(Ref. Technical Letter F500-L14-012)

Alternative Runway Configurations for the Nuevo Aeropuerto Internacional de la Ciudad de México

Aeropuertos y Servicios Auxiliares

January 2014

Figure 3. NAICM Alternative 2 Runway Configuration

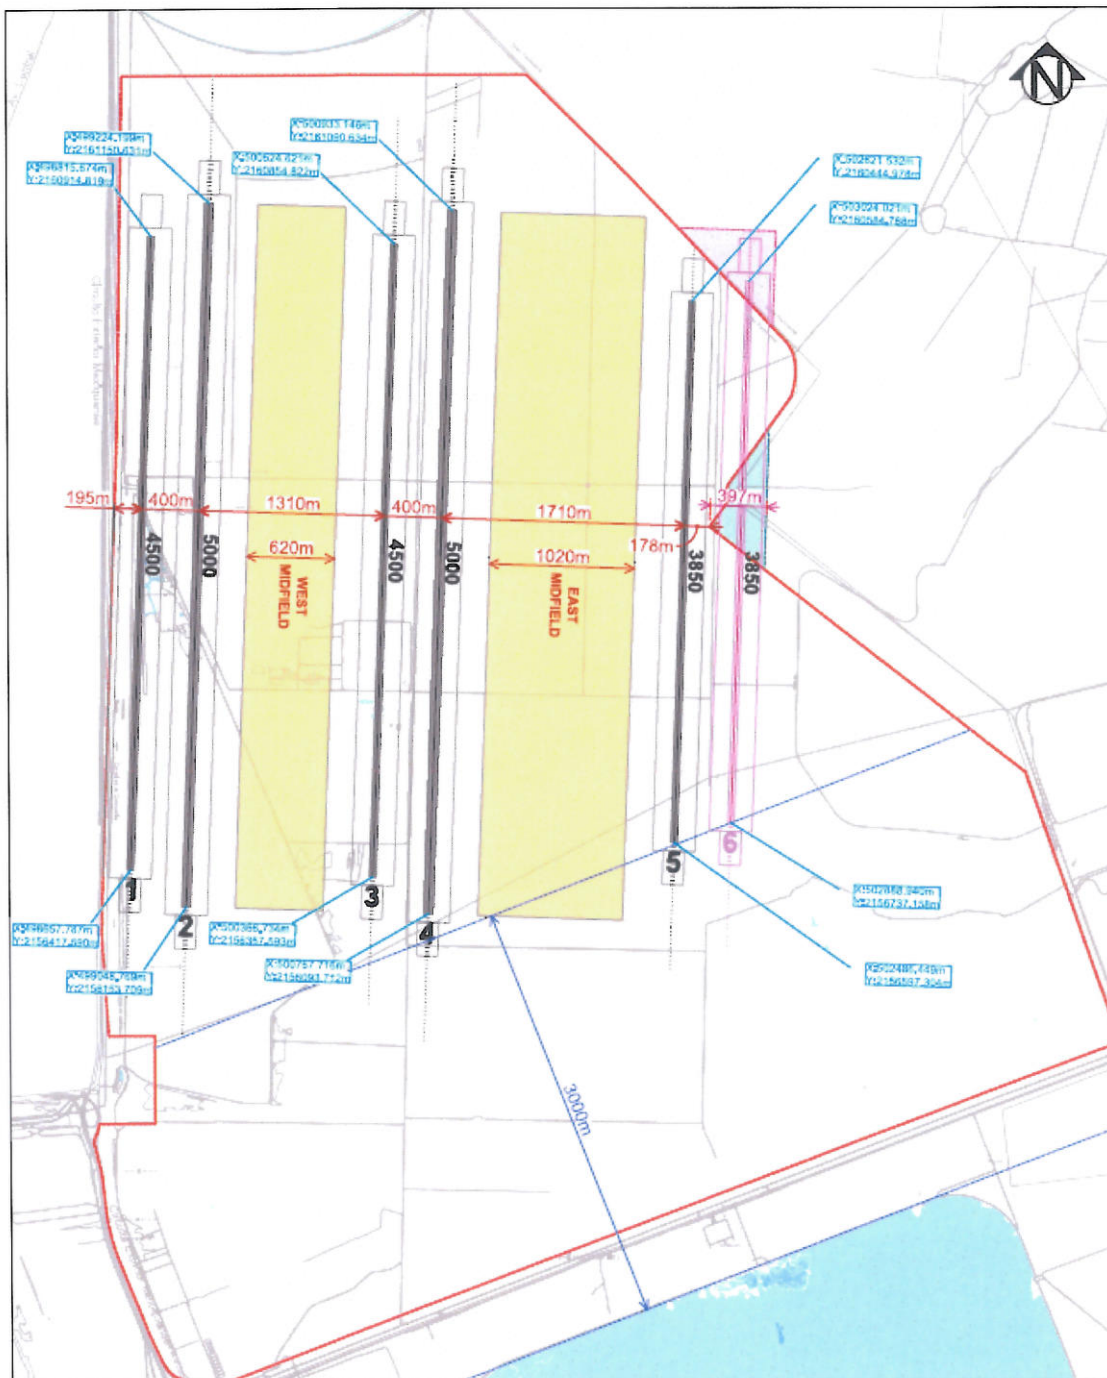
The eastern runway pair (Runways 5 and 6) are only 3850 m in length. This is a significant reduction from the 4500 m runways being proposed in MITRE's configurations. Although this length is just slightly shorter than the runways at the existing Benito Juárez International Airport in Mexico City, it is likely that in the future there may be a significant number of aircraft that would require one of the other longer runways, especially for takeoff. Although there are two 5000 m runways in the design, the need to assign a significant number of aircraft departing to or even arriving from the eastern periphery of the terminal area will complicate the airspace design, as described below.

The width of the runways was measured in the ASA-provided AutoCAD drawing. The two 5000 m runways have a width of 60 m. However, the other four runways have a width of only 45 m. MITRE recommends that all runways have a width of 60 m.

It appears from the drawing and runway lengths that the nominal runway-use strategy would be to operate arrivals on Runways 1, 3, and 5 and departures on Runways 2, 4, and 5. Runway 5 would operate in mixed mode, which would reduce overall capacity. When Runway 6 is constructed, not a clear development from the information received by MITRE, arrivals would then shift to that runway, leaving Runway 5 as a departure runway.

The design of the *NAICM Alternative 2 Runway Configuration* appears to plan for the east midfield terminal to be the main passenger facility (with an east-west dimension of 1020 m); the smaller west midfield terminal (with an east-west dimension of 620 m) would serve a supporting role. MITRE had always planned on locating the main terminal between the western and center pairs of runways.

Additional information provided to MITRE by ASA after 26 November 2013 indicates that the rationale for locating the main terminal between the center and eastern pairs of runways is due to soil drainage issues on the western part of the site. However, the MITRE team feels that, regardless of where the main terminal is built, these issues need to be resolved in order to construct the western pair of runways and other airport related facilities and components. Otherwise, triple approach capacity will not take place and overall capacity will lead to an airport saturated relatively soon. Furthermore, MITRE recommends that the most extreme runways, i.e., Runways 1 and 6 be constructed first, in order to “stake claim” on that land.

Note that if the terminal building were to be constructed in the area to the east of the center pair of runways and Runway 6 were never built, then the operation of the airport would be significantly less efficient compared to if the main terminal were placed to the west of the center pair (the most efficient operation is when the terminal is located between the main runways or runway pairs). Moreover, aircraft requiring the longer 5000 m runway (i.e., Runway 2) would need to taxi a much longer distance.

The design of the *NAICM Alternative 2 Runway Configuration* appears to provide sufficient distance from boundaries and other nearby infrastructure, such as the major drain (*dren*). There are at least 3 km from all runway ends to Lago Nabor Carrillo.

The design of the *NAICM Alternative 2 Runway Configuration* provides only 190 m of separation between the parallel taxiway and Runways 2 and 3 and Runways 4 and 5 (on the side of those runways adjacent to the terminal buildings). MITRE recommends, however, 200 m of separation between runways and parallel taxiways. This may not be a significant issue, however, as the dual parallel taxiways utilized in the design may provide more flexibility for aircraft maneuvering. Nevertheless, MITRE recommends that the maneuvering of very large aircraft (such as the Airbus A380) be further evaluated.

As mentioned above, the relatively short 3850 m length of the eastern runway or runway pair could result in a significant proportion of aircraft requiring one of the other runways (particularly for takeoff), depending on how NAICM and its fleet mix evolve in the future. This will increase the need to vector traffic within the terminal area such that an aircraft that is using one of the longer runways can exit the terminal area in the east. The conceptual airspace design developed by MITRE for use with NAICM would need to be modified for this purpose, and this need to vector aircraft around the terminal area may add to the complexity of operations and controller workload.

Figure 4. Comparison of the NAICM Alternative 2 Runway Configuration, Shown in Black, to the MITRE-Recommended Runway Configuration (July 2012), Shown in Red

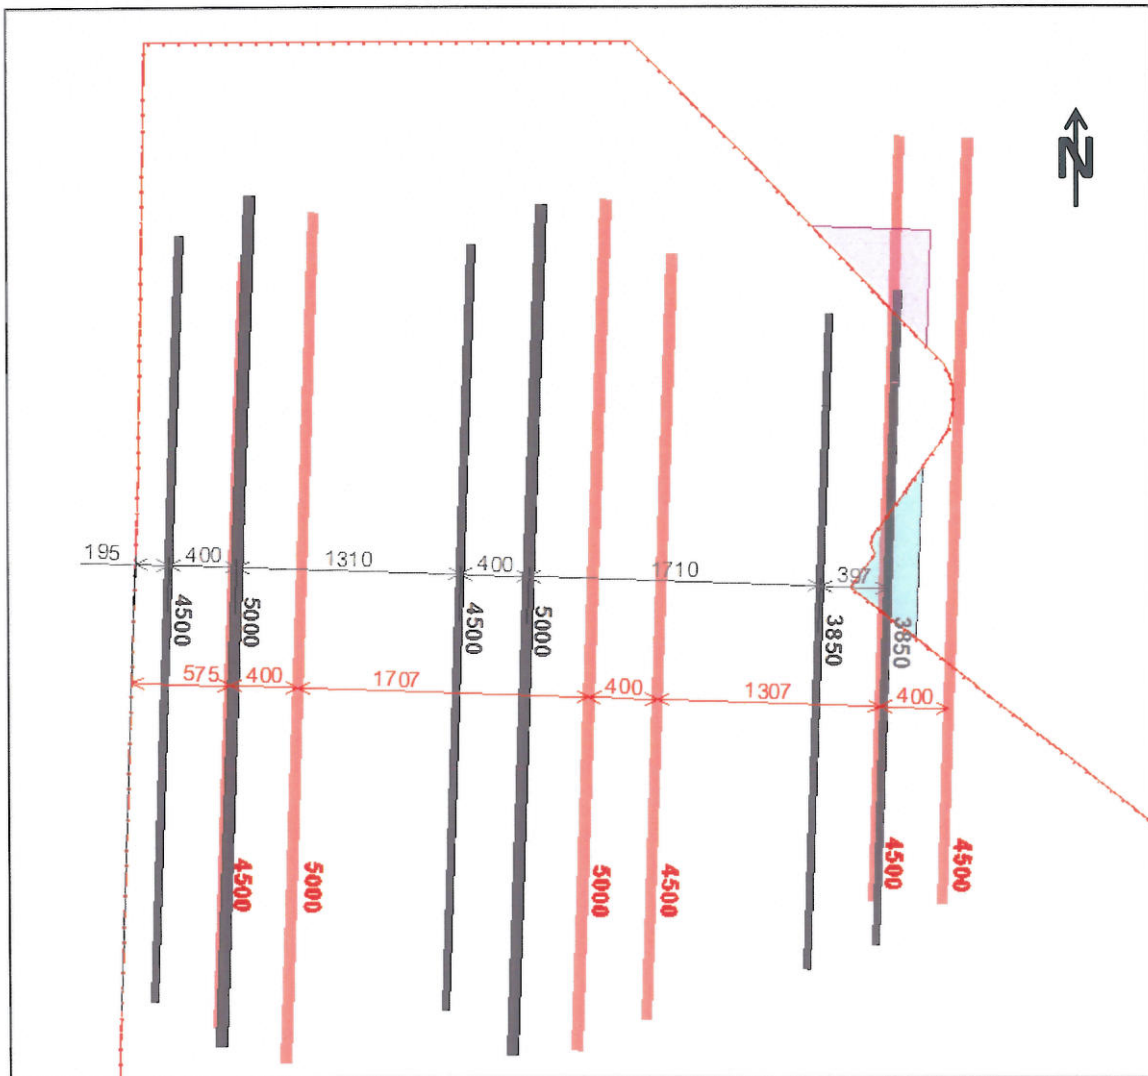
The operational flexibility of the *NAICM Alternative 2 Runway Configuration* is therefore equivalent to that of the *NAICM Alternative 1 Runway Configuration*, but clearly less flexible than the MITRE-Recommended Runway Configuration (July 2012).
